FLORIDA POWER CORPORATION
ST. PETERSBURG, FLORIDA
CRYSTAL RIVER PLANT 855,000 KW
ELECTRICAL MAIN CONTROL BOARD
PRIMARY SECONDARY AUXILIARIES ASSEMBLY
APPROVED
FOR CONSTRUCTION BY
FLORIDA POWER CORPORATION
NUCLEAR PROJECT MANAGER

DATE	ENGR.	3/4	5500	D-201-151	11	E-201-151
RELEASED FOR	ENGR.	DATE	WORK ORDER	SIZE	DRAWING	REV

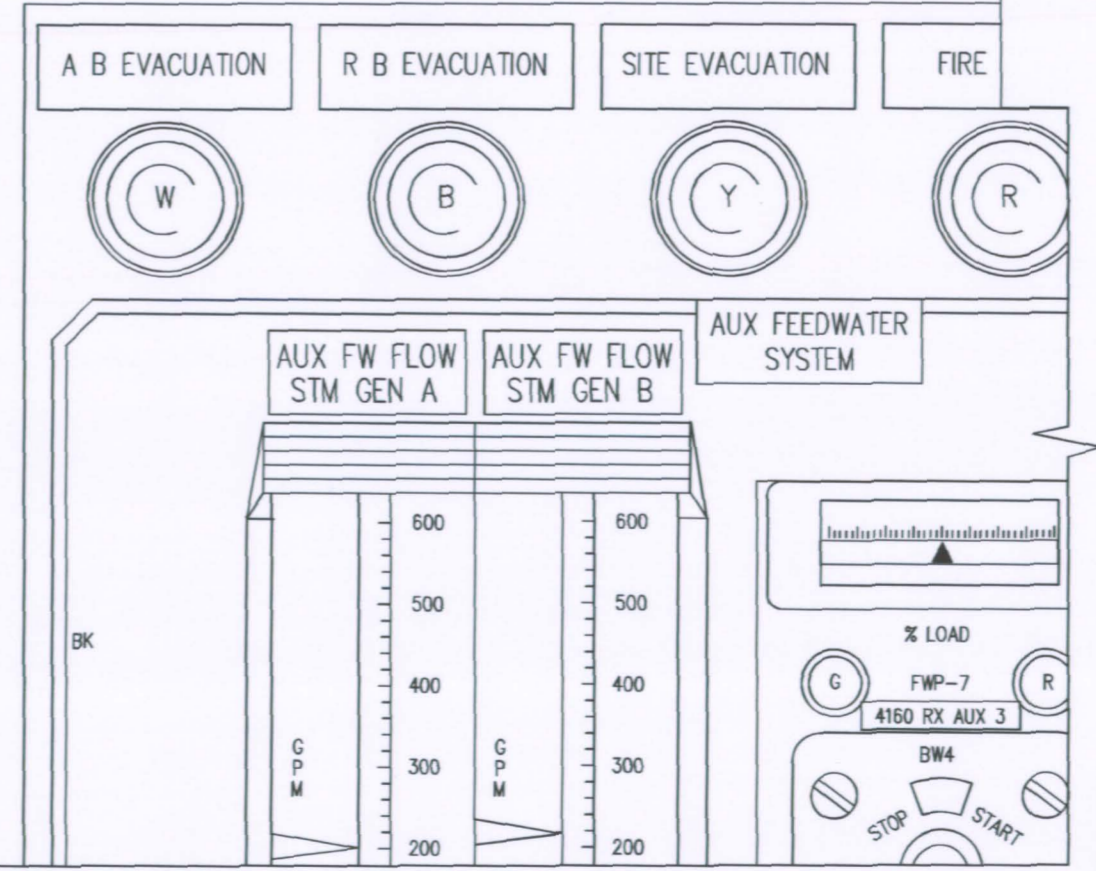
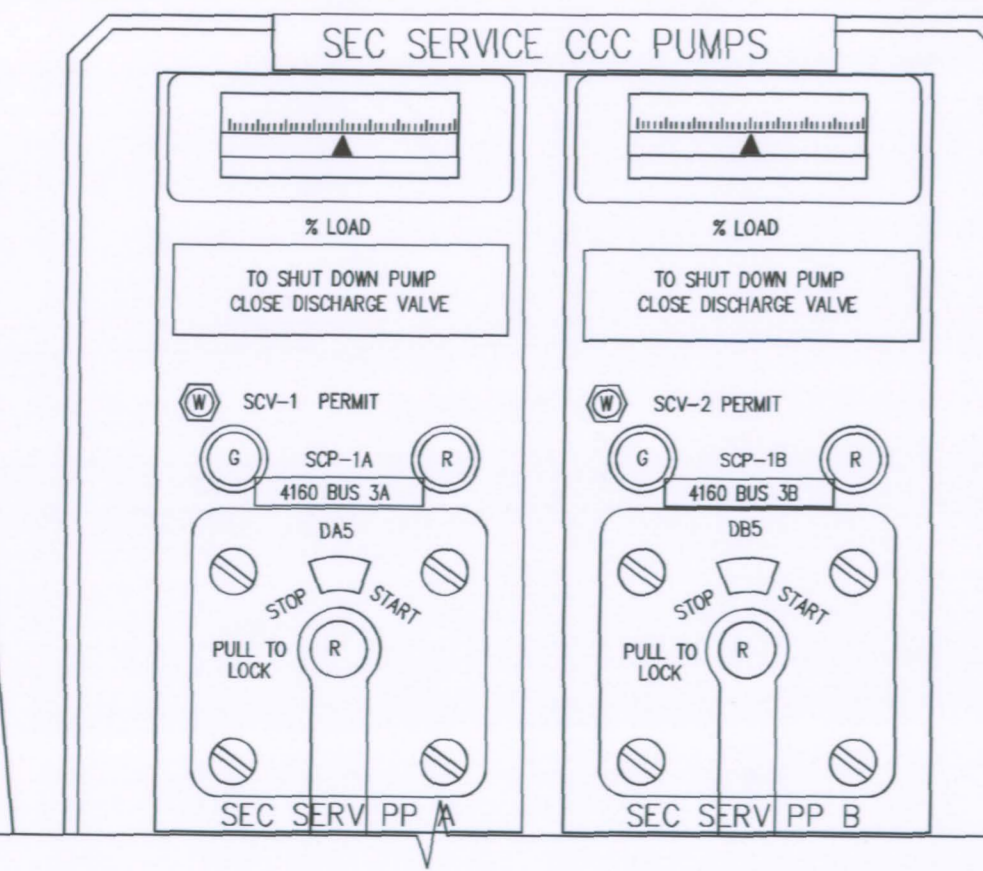
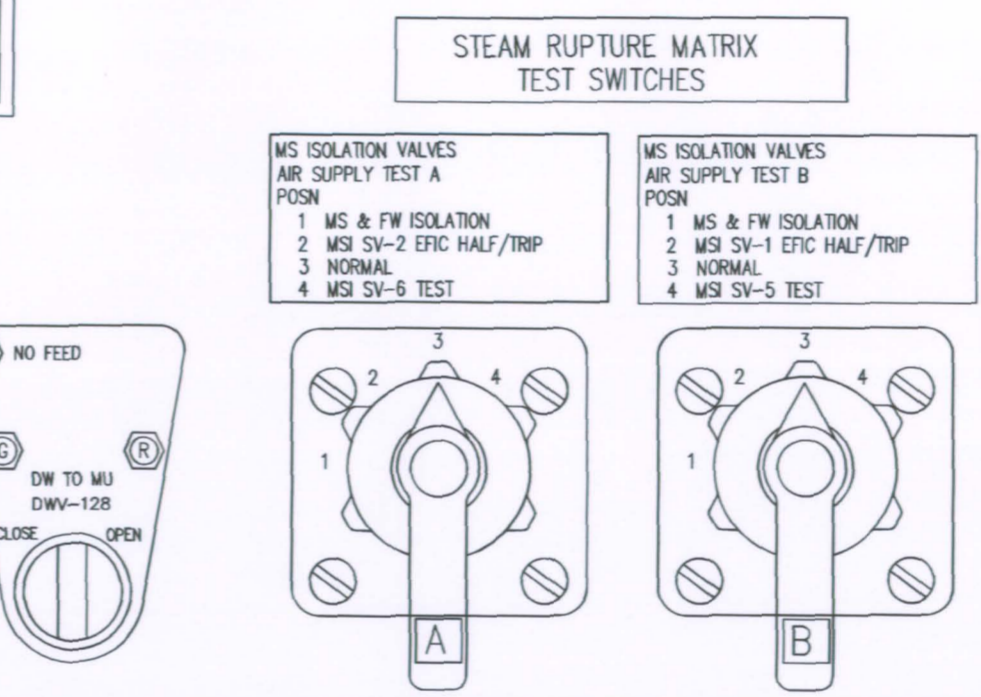
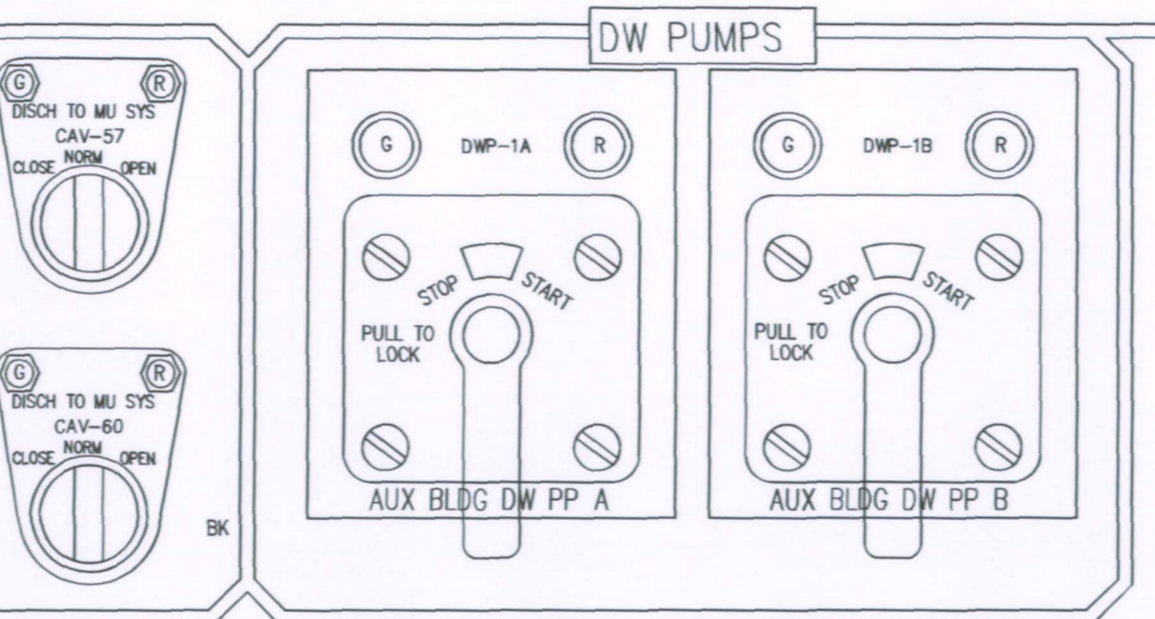
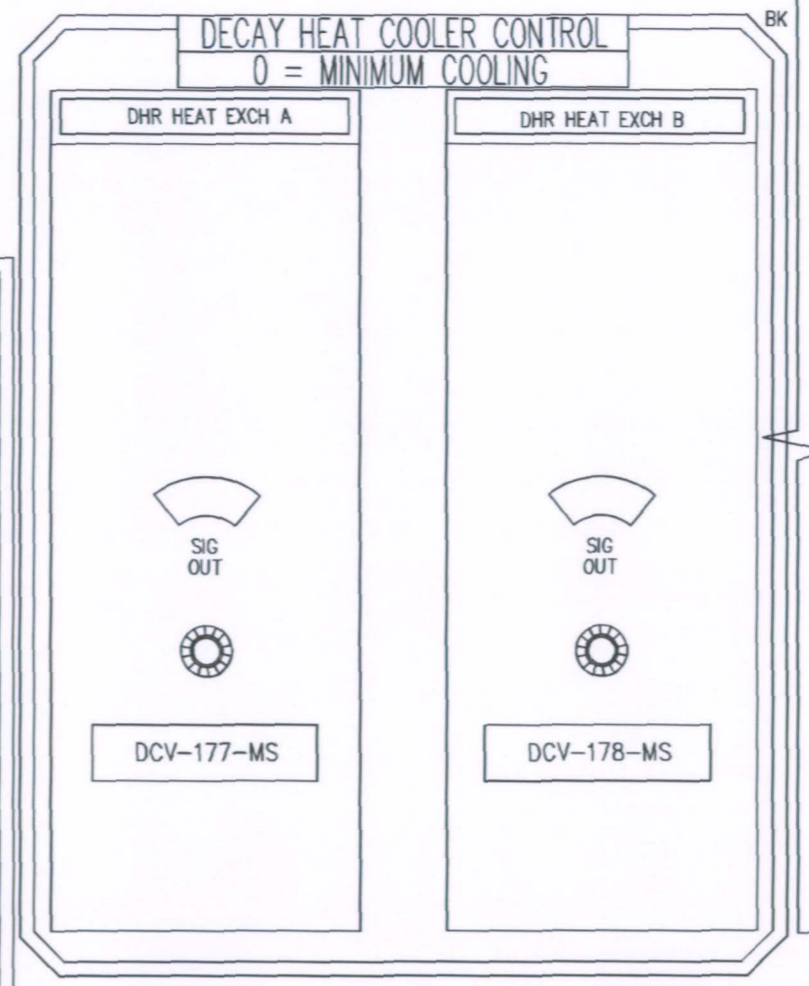
Relocation and consolidation of existing indicators.

SEE NOTE 1
